DELEGATED APPLICATION REPORT

Address: Land at Wensley Road, Reading

Application No: 220434/NMA

Proposal: Non-material amendments to permission 200122 (granted on 16/12/2020 for redevelopment to provide 46 new dwellings and associated works) including relocation of air source heat pumps, various window and door alterations, increase in column widths on south elevation of Block B2, changes to cycle and waste storage facilities, inclusion of satellite dishes & other associated building alterations

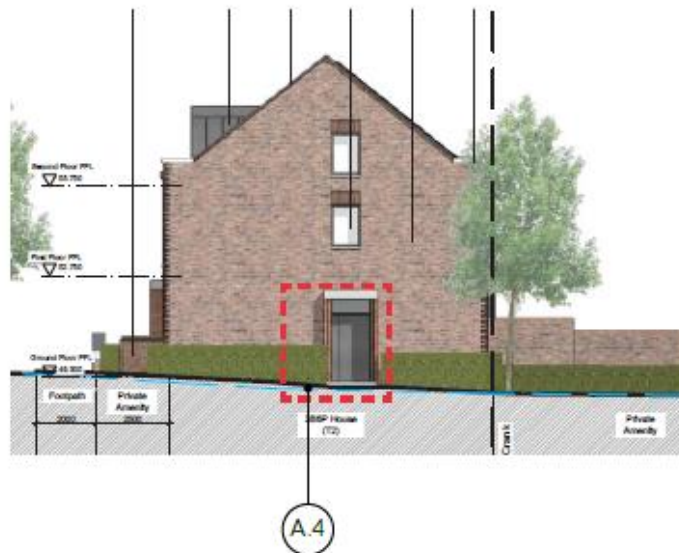
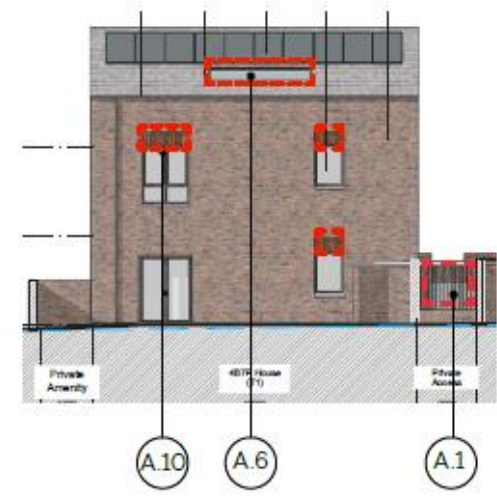
A.1	ASHP moved within the rear garden, adjacent to the houses
A.2	Water butts and additional rainwater pipes added
A.3	Ground floor WC increased to meet M(4) requirements
A.4	Ground floor WC and entrance door flipped to resolve internal layout
A.5	Material of individual refuse stores changed from brick to perforated metal
A.6	Roof light to stairs omitted and replaced with window on the rear elevation
A.7	A2 Ground FFL changed from 48700 to 48900. Upper floor FFLs and ridge height also raised by 200mm.
A.8	Minor Amendments to parapet and ridge heights
A.9	Satellite dishes added
A.10	Brick soldier detailing removed above window on rear elevation

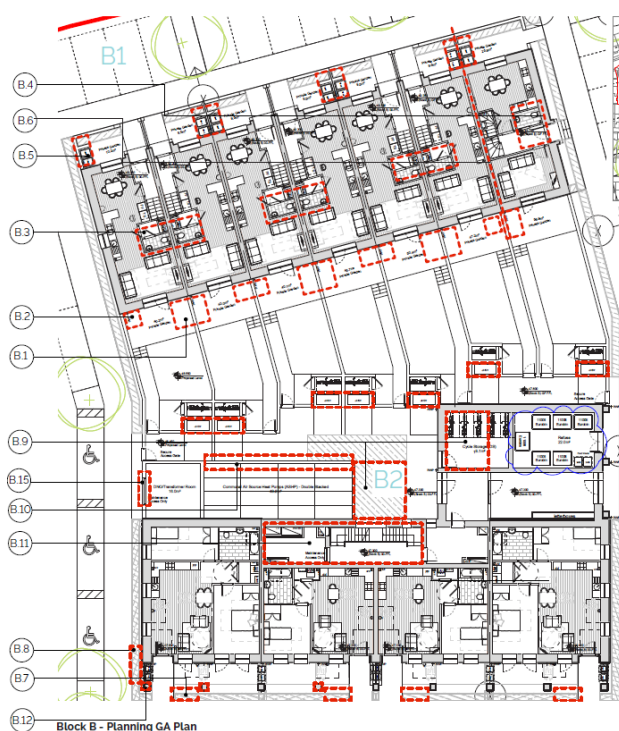
B.1	ASHP moved within the rear garden, adjacent to the houses.
B.2	Water butts and additional rain water pipes added.
B.3	Ground floor WC increased to meet M(4)2 requirements.
B.4	Ground floor WC and entrance door flipped to resolve internal layout.
B.5	Material of individual refuse stores changed from brick to perforated metal.
B.6	Step in ground floor FFL increased from 450mm to 750mm
B.7	Location of individual refuse store to ground floor flats amended.
B.8	Refuse presentation points added.
B.9	Communal Cycle store relocated to provide pram store internally.
B.10	Communal ASHP enclosure changed from brick to acoustic louvres.
B.11	Communal staircore reconfigured in accordance with AD Part B , with window locations and sizes amended to suit.
B.12	Columns to apartment block increased from 440mm to 625mm .
B.13	Change to third floor balcony, east and west elevation from metal railings to brick.
B.14	Juliette balconies replaced with window and brick panel below.

B.15	Access to water tank relocated to rear garden access route.
B.16	Obscured bedroom windows omitted. Windows added to refuse stores.
B.17	Minor Amendments to parapet and ridge heights.
B.18	Satellite dishes added.
B.19	PV panels removed from B2 east roof due to overshadowing

* the ground floor plan was revised during the course of the application to show a door remaining on the east elevation to serve the waste store provision and further details concerning the cycle parking.

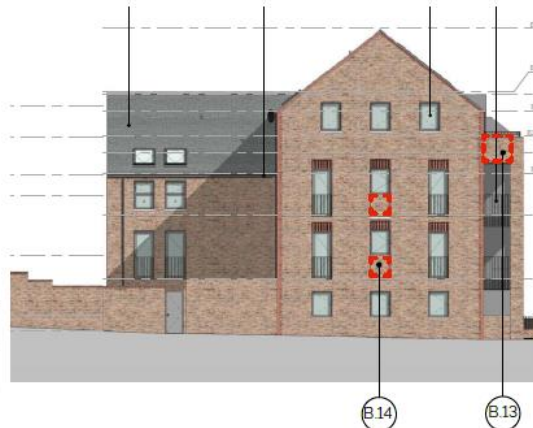
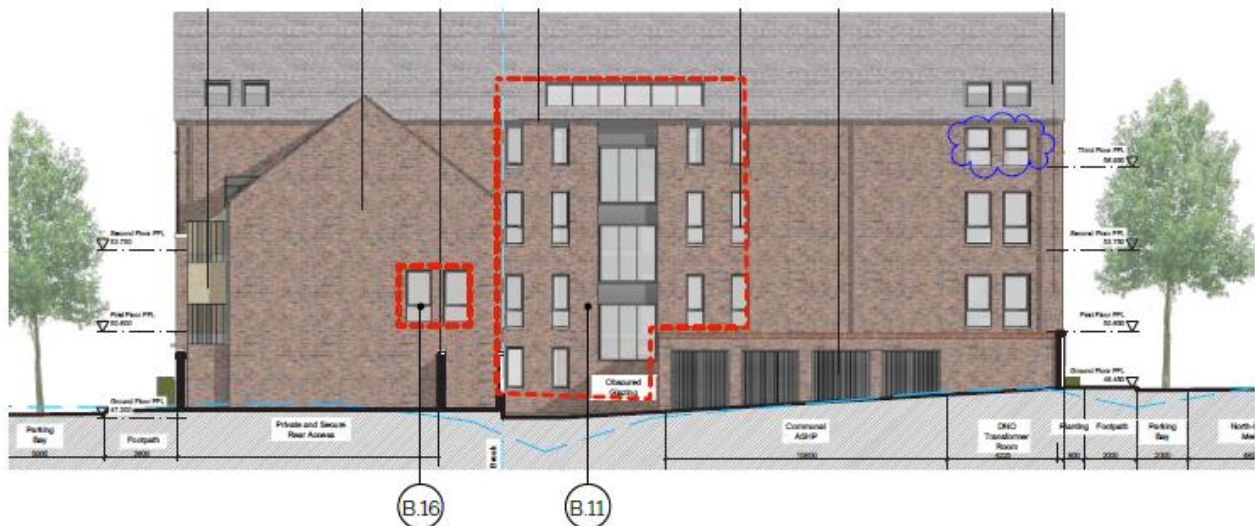
* During the course of the application a door on the east elevation to serve the waste store was re-introduced and shown on a revised plan.

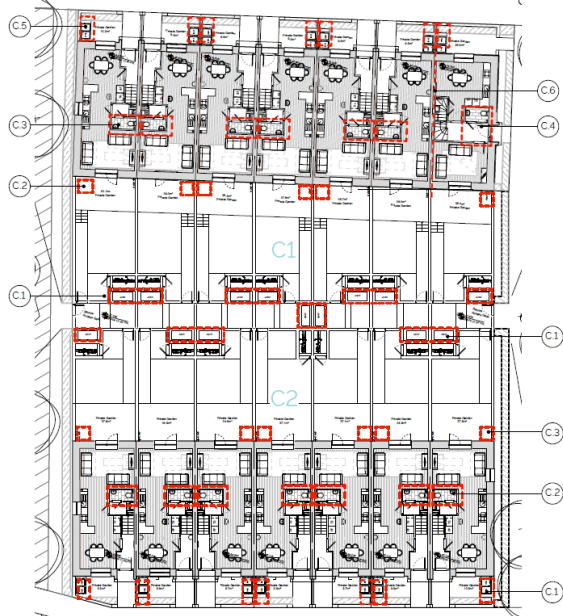
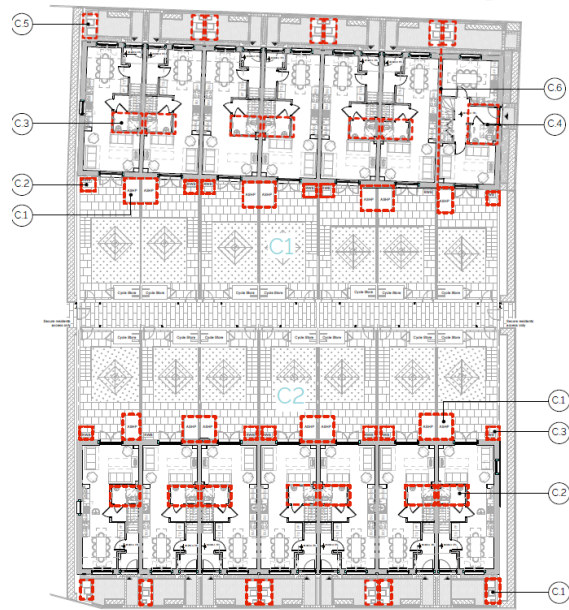
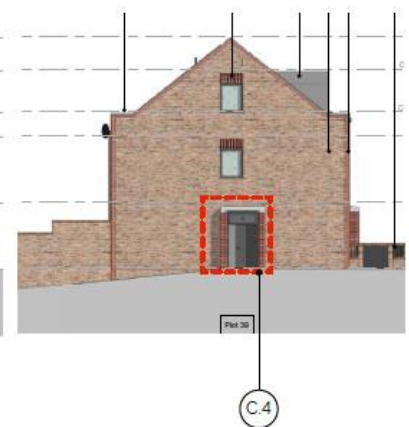
C.1	ASHP moved within the rear garden, adjacent to the houses.
C.2	Water butts and additional rainwater pipes added.
C.3	Ground floor WC increased to meet M(4).
C.4	Ground floor WC and entrance door flipped to resolve internal layout.
C.5	Material of individual refuse stores changed from brick to perforated metal.
C.6	Step in Ground Floor FFL omitted.
C.7	Minor Amendments to parapet and ridge heights.
C.8	Satellite dishes added
